## Product Change Notification / RMES-26BJAP489

CCB 4646 Final Notice: Qualification of MMT as an additional assembly site for various Atmel products available in 8L UDFN (2x3x0.6mm) package.

**PCN #: RMES-26BJAP489**

# LEAD FRAME COMPARISON

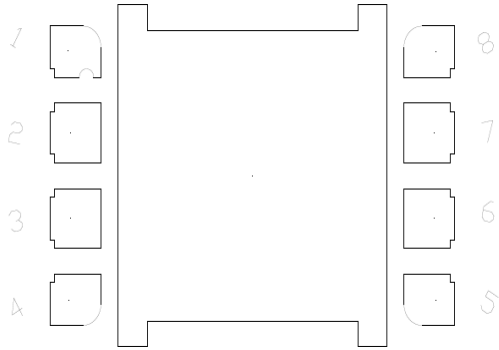
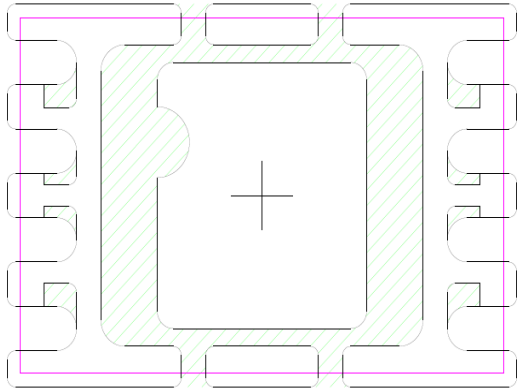
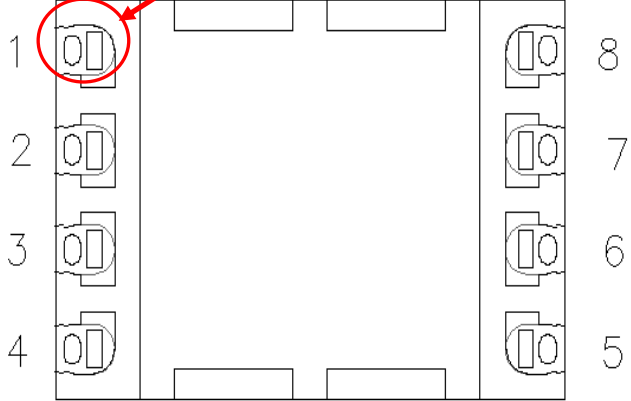
ASE		ATP 7		MMT	
				<p>Lead Lock (Locking Holes)</p> 	
Lead Frame Material	C7025	Lead Frame Material	C7025	Lead Frame Material	EFTEC-64T
Lead Lock	Yes	Lead Lock	Yes	Lead Lock (Locking Hole)	Yes
Paddle size	73 x 67 mils	Paddle size	79 x 67 mils	Paddle size	79 x 67 mils

**NOTE:** Mold compound material fills the [lead lock hole](#), which provides improved protection against moisture penetration along the edge of the leads (pins) of the package.
